Product Change Notification

MODULAR CONTACTS

Bourns Trimpot Product Line Announces ***Change to Carrier Tape Width & MOQ for Model 70ABJ-4-Male Modular Contact***

Figure 1: 70ABJ-4-Male Current Design

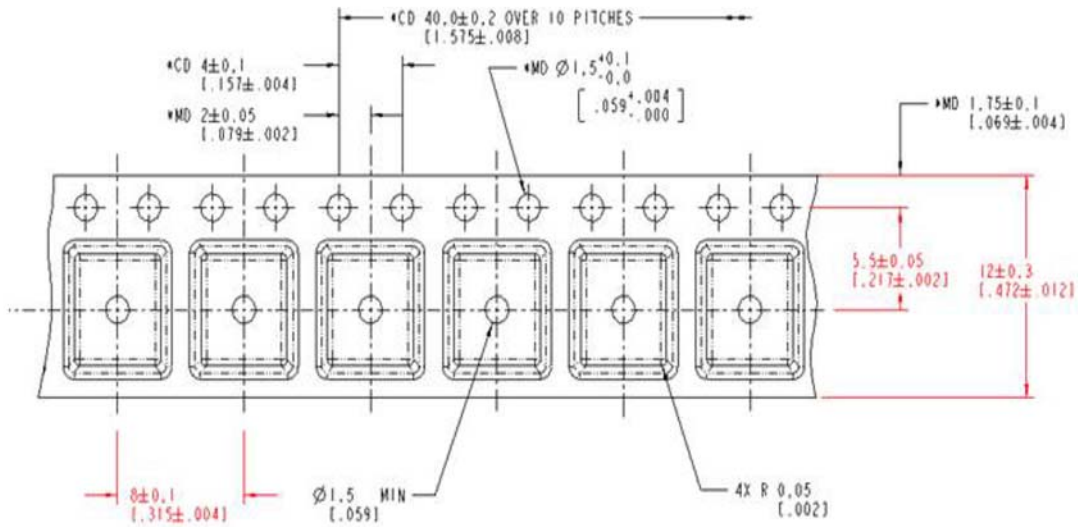
Bourns Trimpot Product Line is changing the carrier tape width for the [Model 70ABJ-4-Male](#) Modular Contact. The carrier width is changing from 12 mm to 16 mm and the carrier tape unit pitch is changing from 8 mm to 12 mm. This improved design helps eliminate the camber effect which can occur after being sealed with cover tape. See Figure 1 and 2 on the next page for the specifications.
